# MILLPWR<sup>G2</sup> SOFTWARE UPDATE

March 30, 2015

**MILLPWR<sup>G2</sup> 2 & 3 Axis**

**(Version R2SP6)**

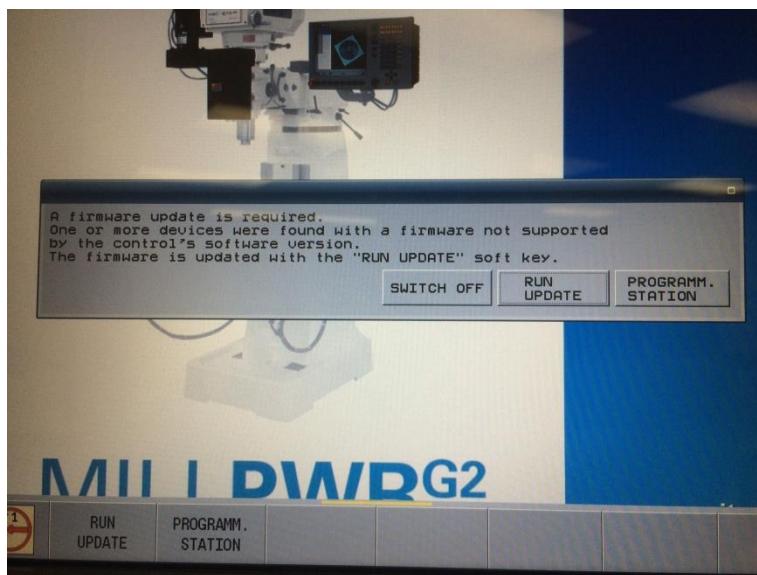
Select **RUN UPDATE** if prompted with firmware update message
